Project Name : Land Adjacent to 21 Greencourt Drive, Bersted

Note Title : Drainage Strategy Technical Note

1.1.3 This technical note sets out details of the proposed drainage strategy in response to the ADC Drainage Engineer comments. The ADC comments are presented in **Appendix A**.

Engineers Comments Regarding Surface Water Drainage

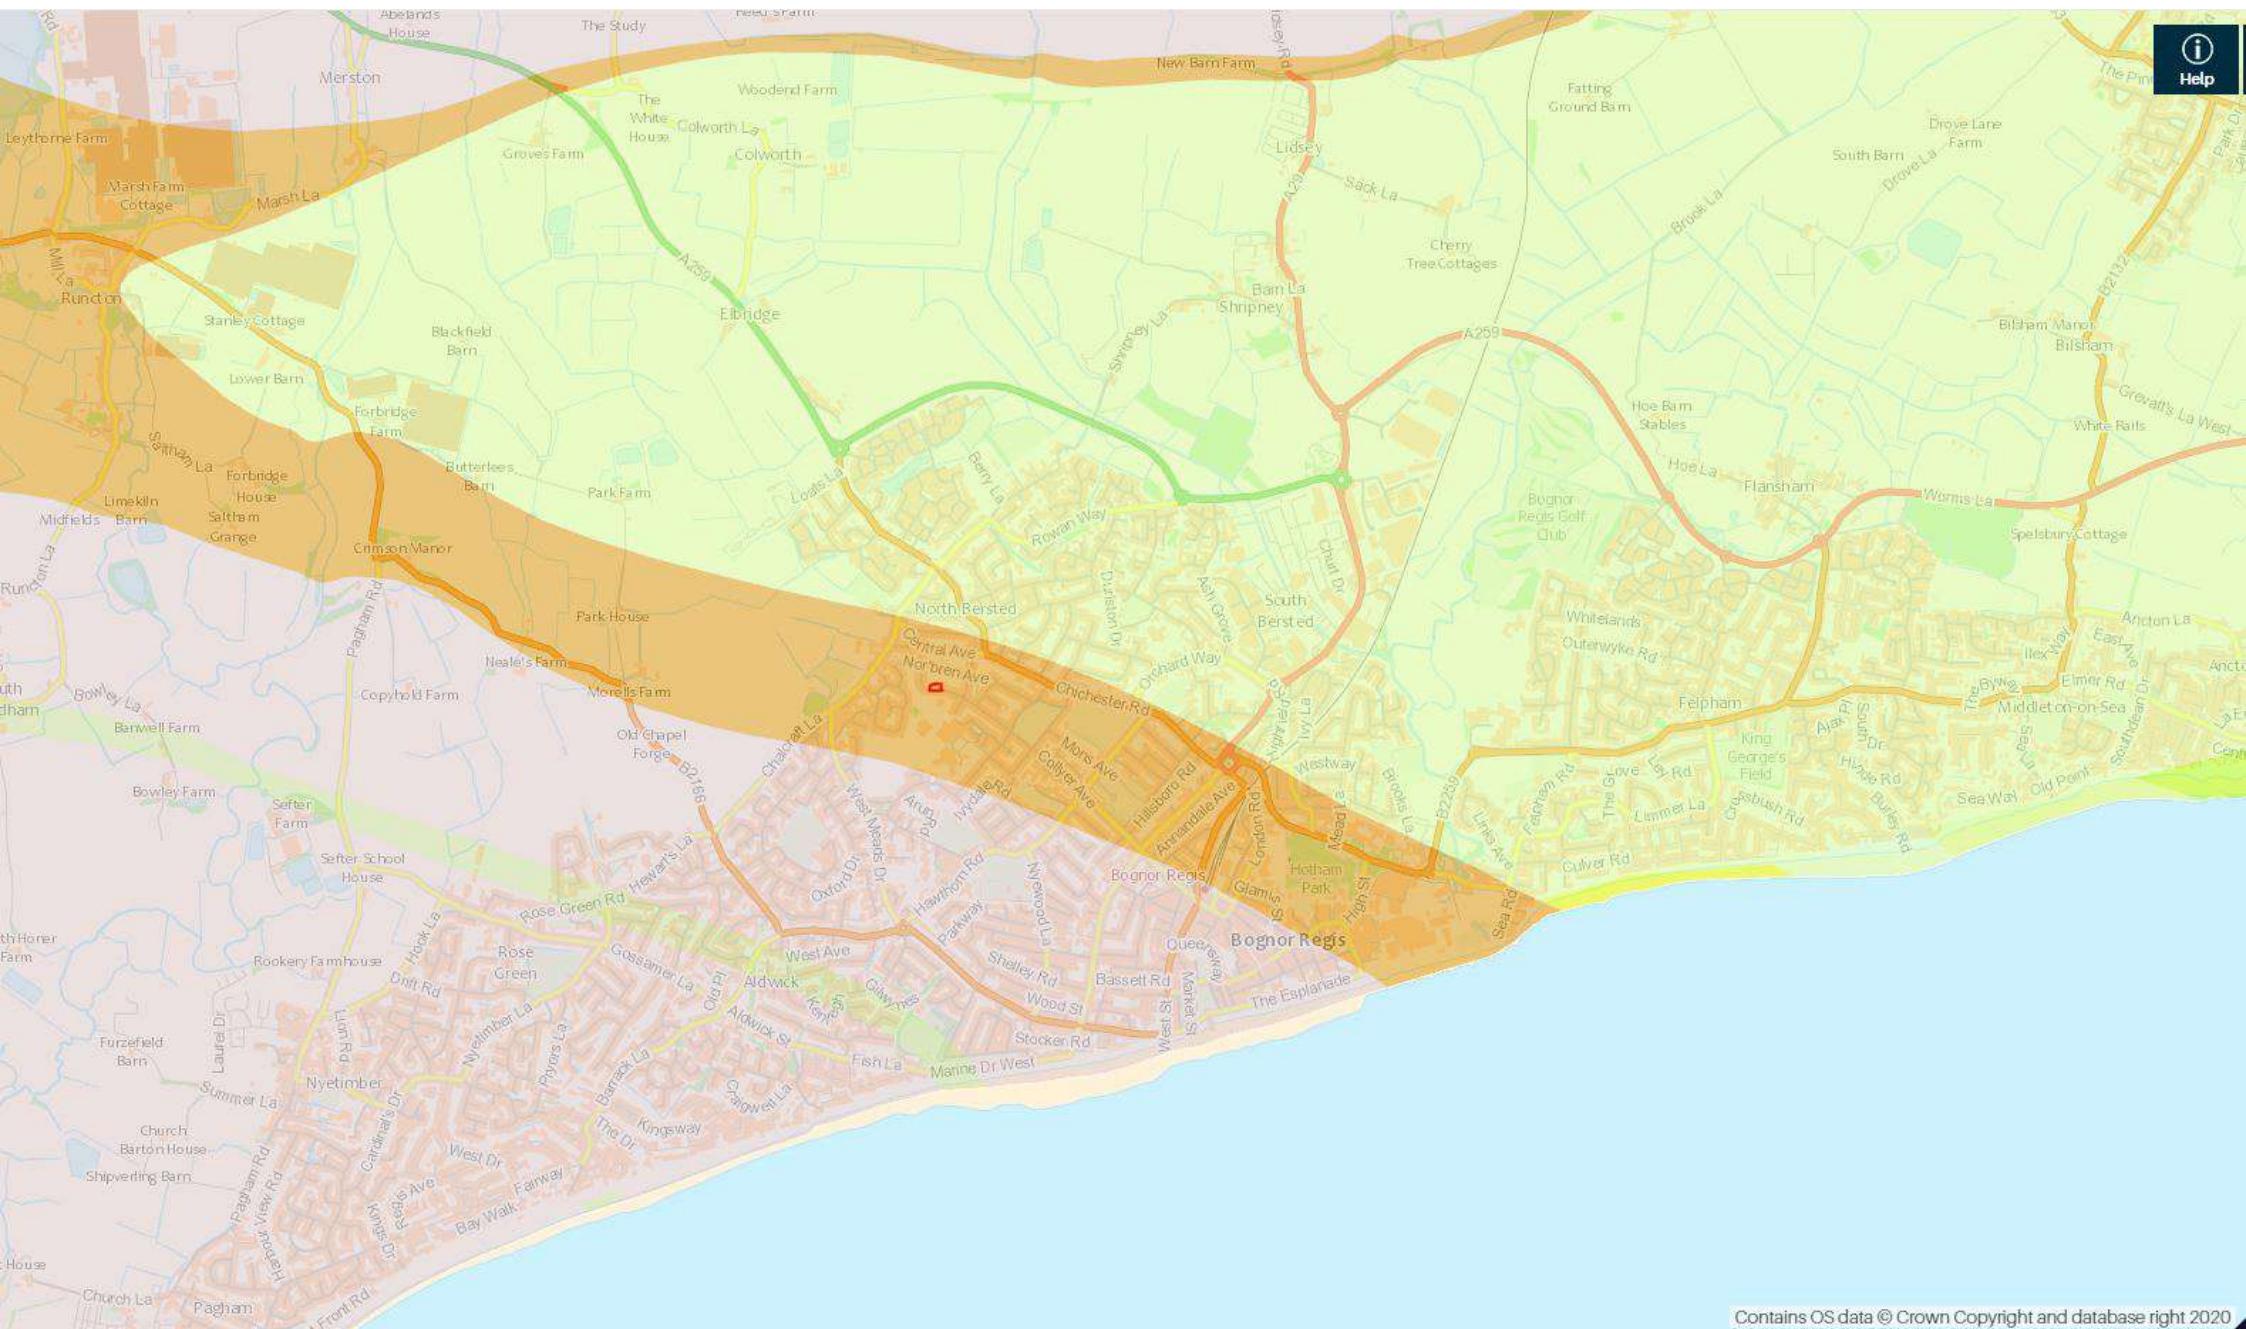
1. The proposed discharge rate is excessive for a development of this scale and exceeds the requirements of the National Standards . In this instance, we are prepared to agree a rate of 0.5 l/s in order to help provide a practical solution. Restricting flows to such rates, will result in a flow control device of a small diameter, which needs protection from blockage. However, provided all flows pass through the permeable paving, as currently proposed, then this will act as a means to reduce the risk of blockage. Additional measures can be incorporated as part of the detailed design at a later stage. A suitable revised scheme therefore needs to be provided, to accommodate the increase in storage required, etc.

2. Evidence of permission in principle from Southern Water is required, in respect to the proposed connection of surface water to the Public Surface Water sewer, at the discharge rate discussed above.

3. The applicant should note that the existing manhole being connected to at the junction of Greencourt Drive and South Way may be at a slightly different location to that shown on the drainage layout plan ie. more into the footpath. Also, it would be advisable to ensure that no third party utility mains/services, including the existing highway drainage in Greencourt Drive, conflict with the routing and levels of the proposed pipework, etc. This matters may result in having to reconfigure the proposed offsite pipework to enable a suitable connection.

4. It is noted that there will be a considerable length of 'offsite' pipework and associated manhole/s. Confirmation is required as to whether these assets are to be adopted by a Water Company. Evidence of agreement in principle from the Water Company will be required. It is unlikely, that West Sussex County Council (WSCC), as Highway Authority will permit an unadopted arrangement in the public highway and therefore it is important to establish its future status. If adoption is not sought, then confirmation will be required from WSCC that the principle of the arrangement is acceptable to them.

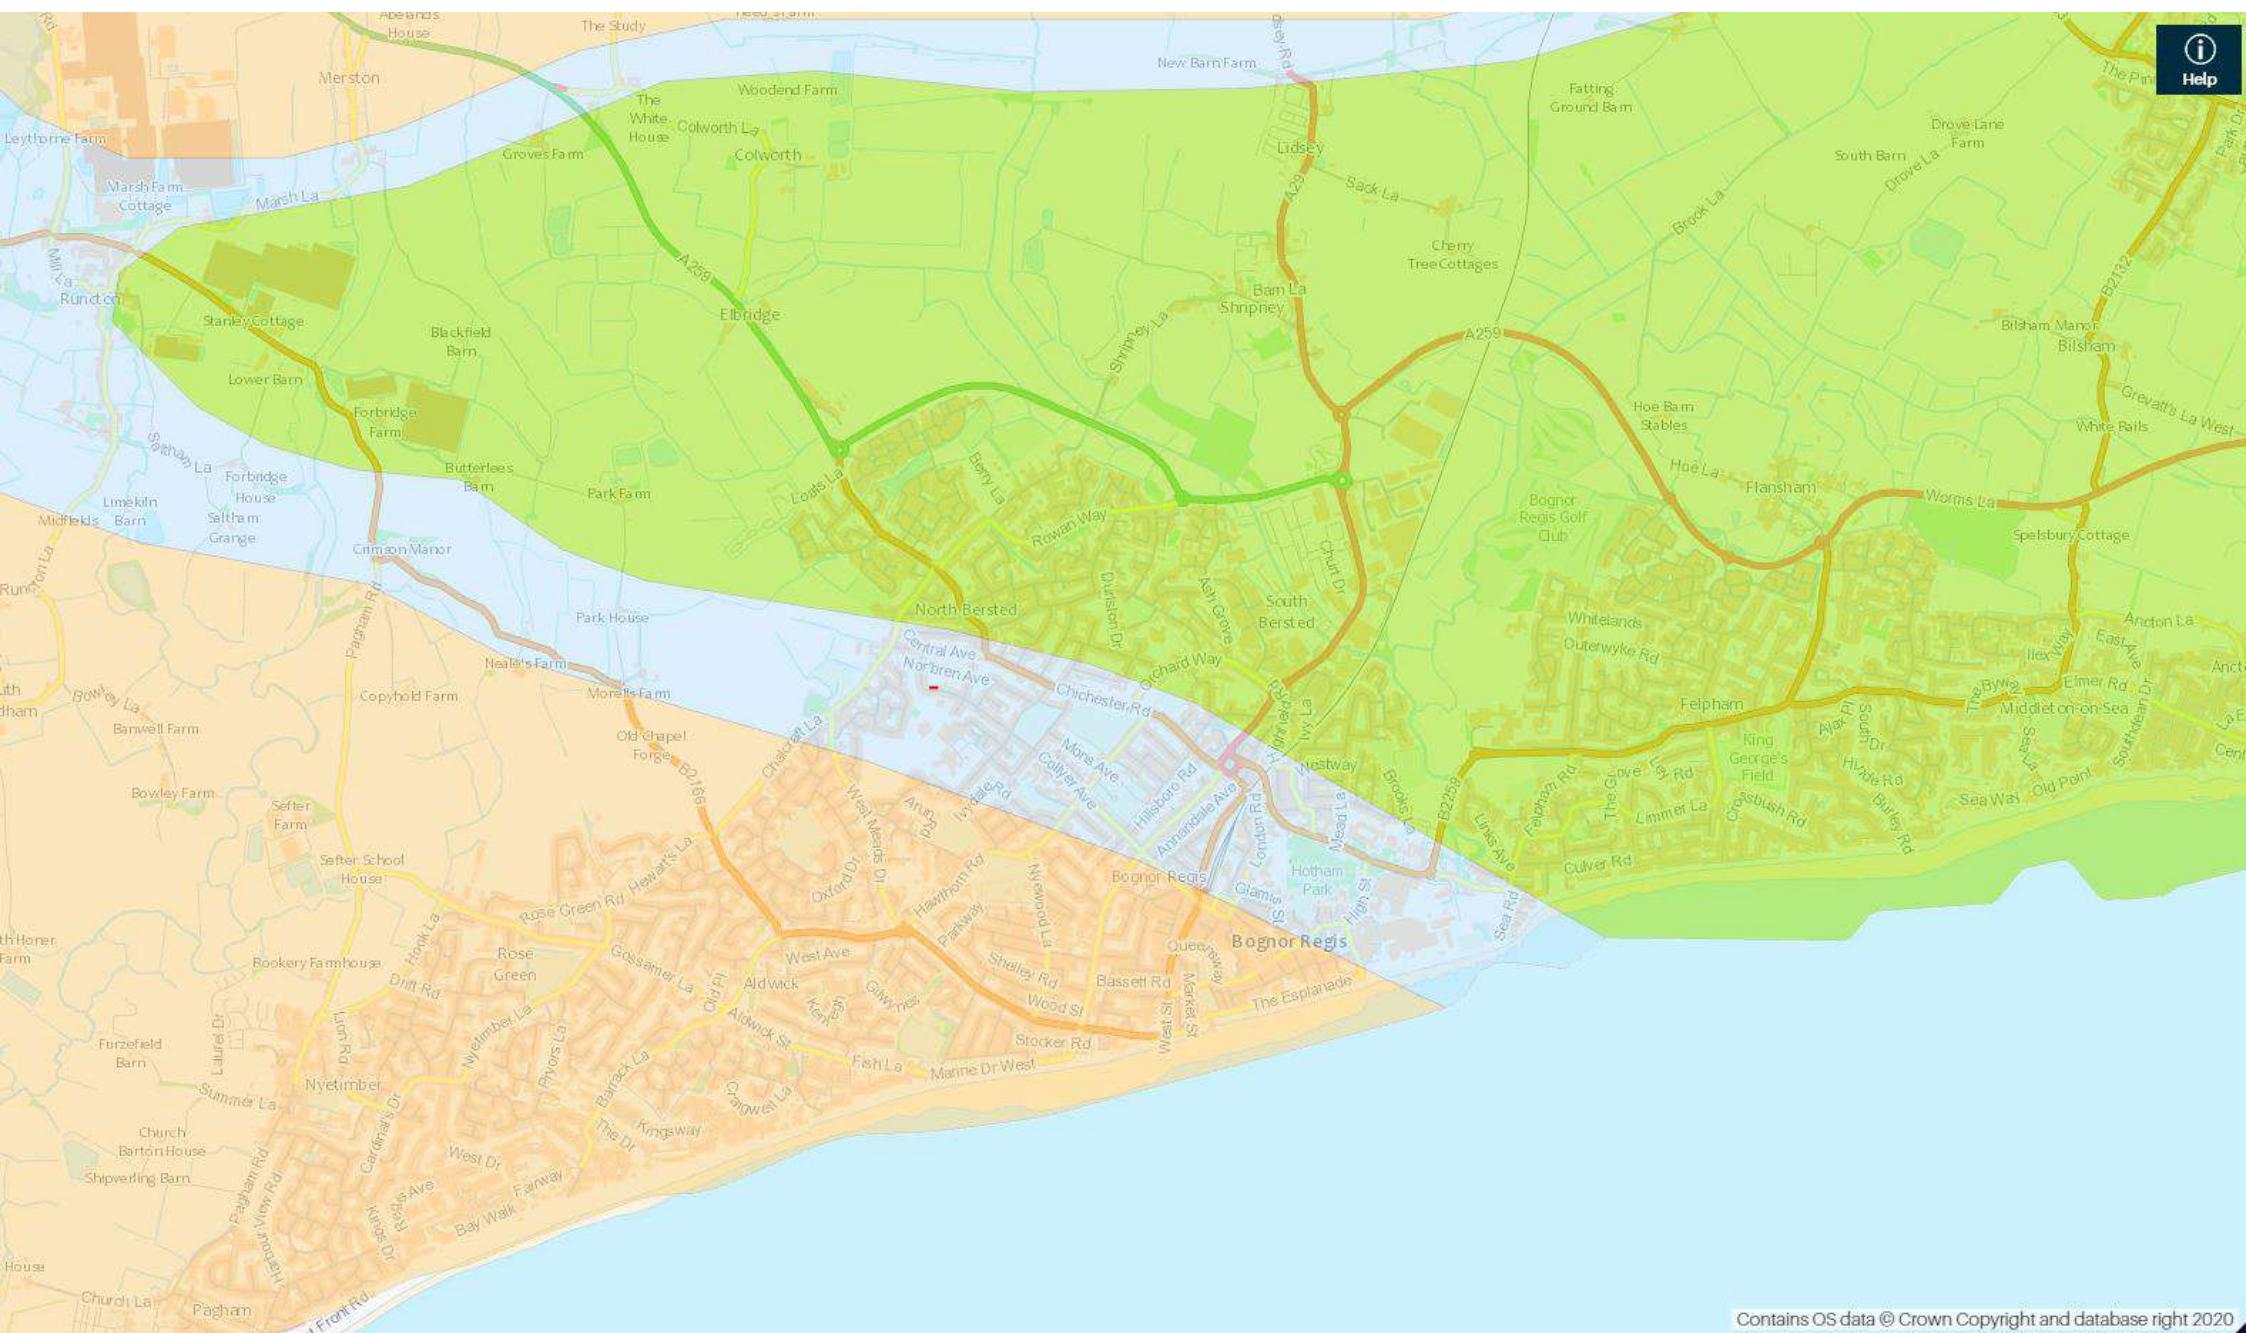
5. The hydraulic calculations have not been checked as a result of item 1. However, they will need to be altered to reflect the revised scheme that is now required. Urban creep at 10% must be included, irrespective of the sites perceived constraints. A surcharged outfall must also be modelled. Ensure that the calculations reflect the invert level of the proposed flow control devices. Provide a copy of the FEH point descriptors file, so they parameters can be checked.

6. Provide an impermeable area plan to support the hydraulic calculations.
7. The drainage layout must include the pipework/manhole arrangements around the two dwellings and show the connectivity to the permeable paving. Manhole cover levels, invert levels, pipe diameters and gradients to be included. All diffuser units (including those linking the permeable pavements) to have inverts specified. Indicate diameters/gradients of all link pipes. Silt traps to be incorporated prior to any discharge into permeable paving.

8. Provide a location plan for the water table monitoring boreholes, to confirm that they are located on site.
9. Interception drainage needs to be considered. This could take the form of smart water butts and/or other methods of rainwater harvesting. Indicate on drainage layout.
